Official Transcript of Proceedings
NUCLEAR REGULATORY COMMISSION

Title: Advisory Committee on Reactor Safeguards
Advanced Boiling Water Reactor
Subcommittee

Date: Wednesday, April 6, 2011

ADVANCED BOILING WATER REACTOR SUBCOMMITTEE

Figure 10.2-5 Turbine Overspeed Trip System Functional Diagram

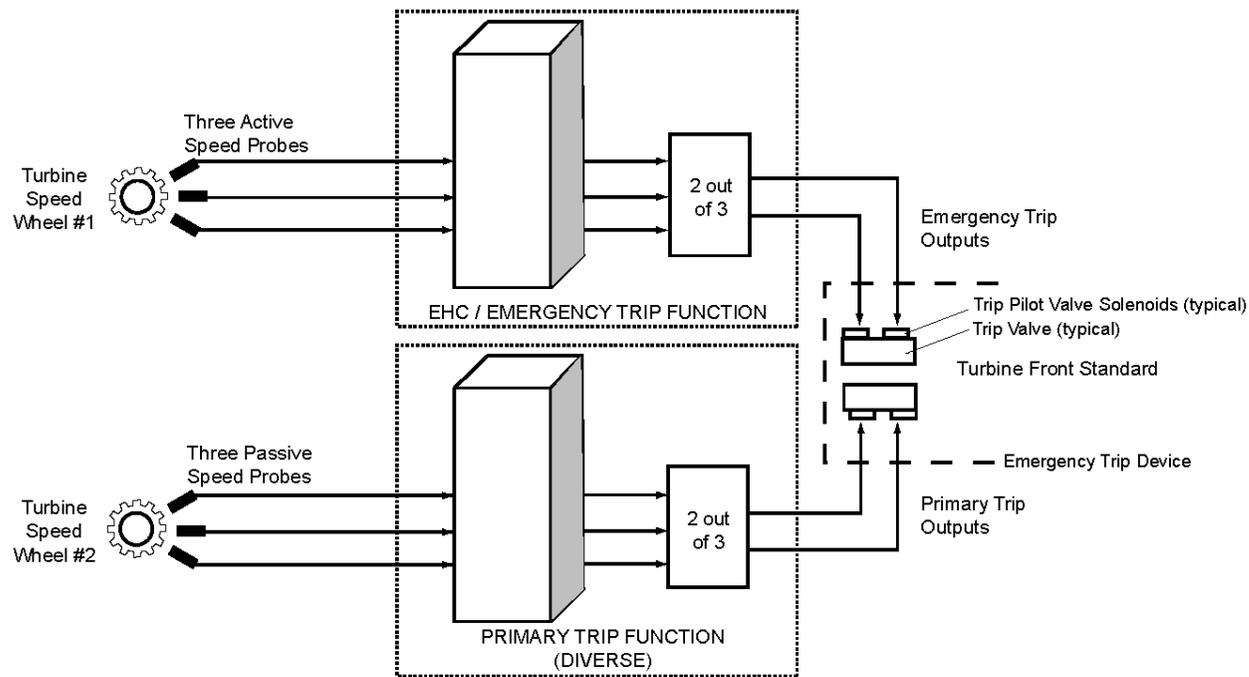
RAI 10.02-4 revised response added a figure to FSAR Section 10.2:

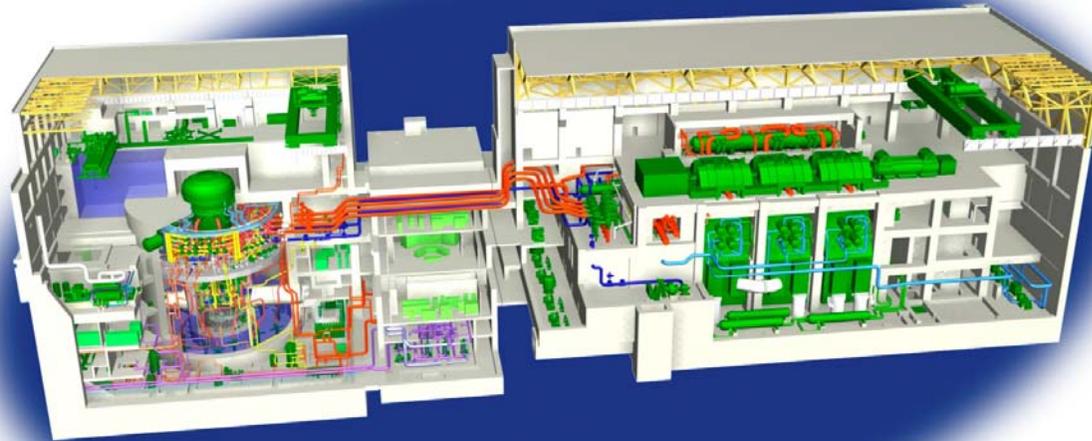
- The applicant proposed a new Tier 1 departure which revised Tier 1, Figure 2.10.2a.
- In the revised Figure 2.10-2a, condensate booster pumps are now included as part of the basic CFS configuration.
- The staff reviewed the proposed revisions to the Tier 1 information and found it acceptable since the information in Tier 1 is now consistent with the plant design described in Tier 2.
- Incorporation of the proposed Tier 1 change is being tracked as a confirmatory Item.

Primary Overspeed Trip and Emergency Overspeed Trip Functions

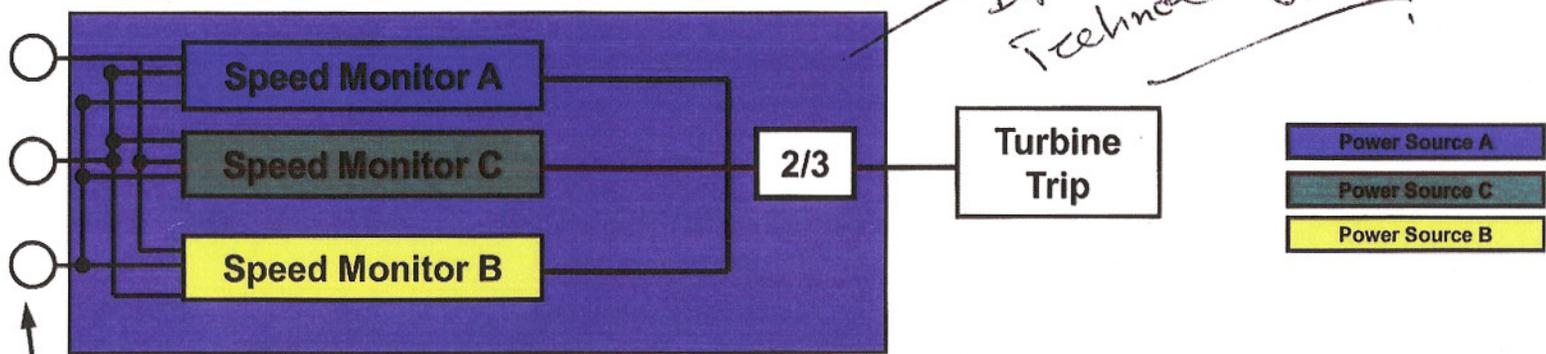
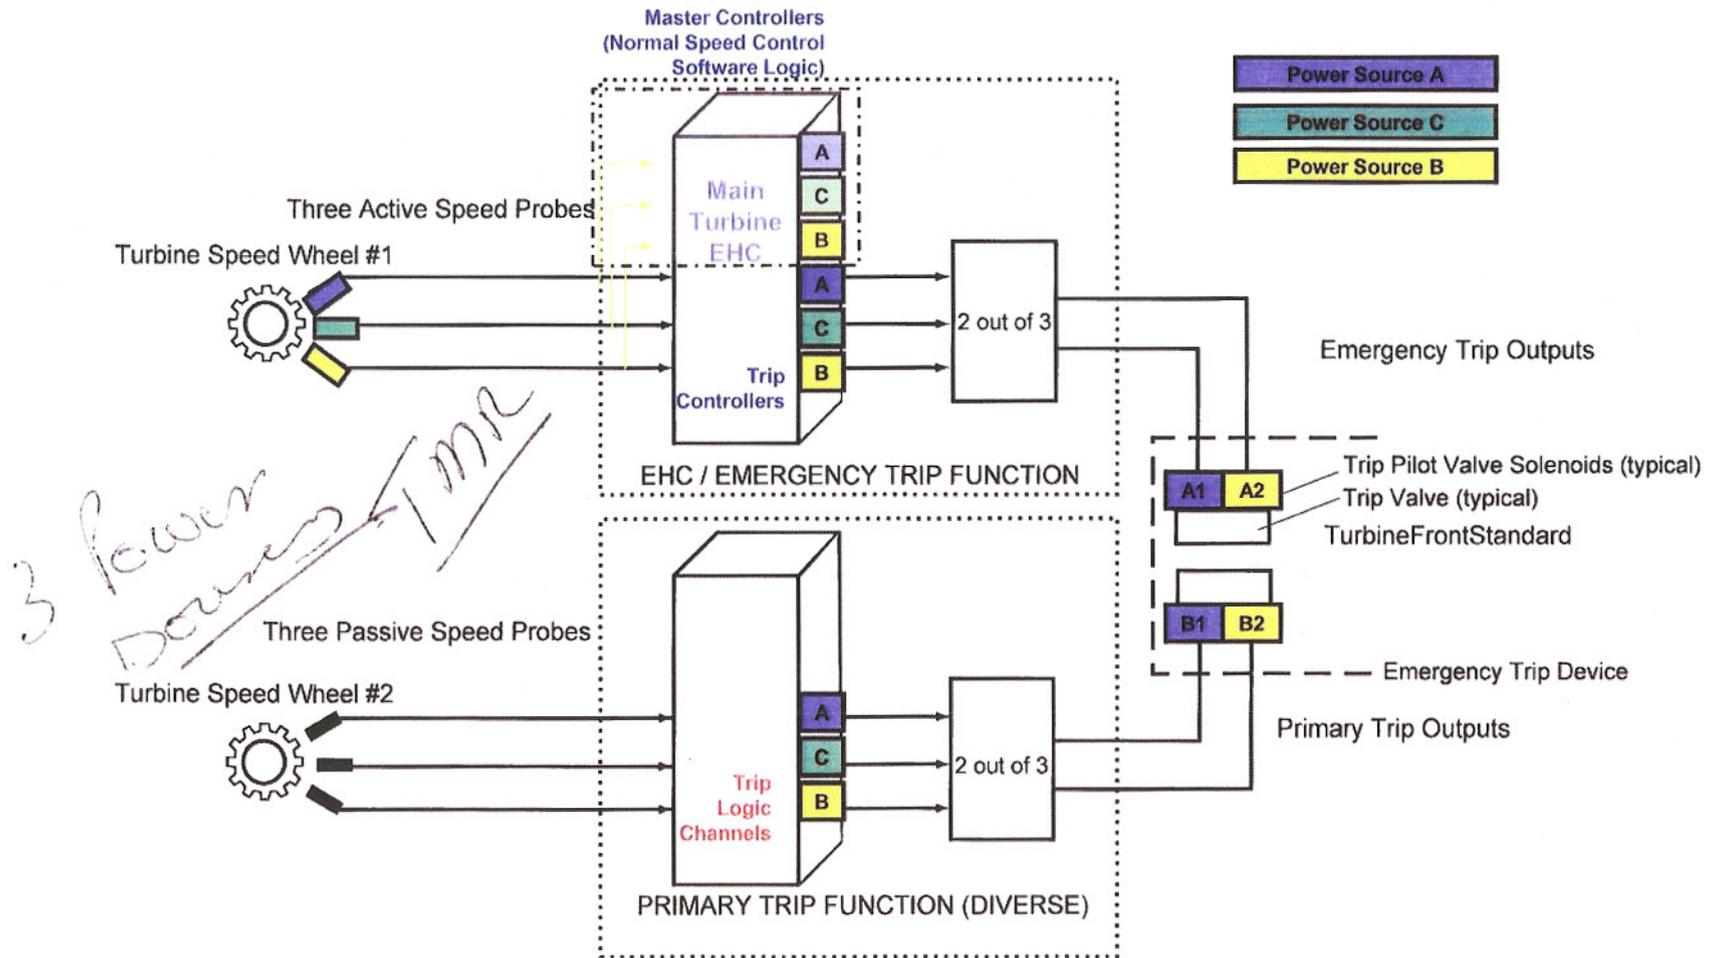
3 Speed Pickups (Active) for Emergency Overspeed Trip Function
(Active detector needs power supply)

3 Speed Pickups (Passive) for Primary Overspeed Trip Function
(Each passive detector needs no power supply)
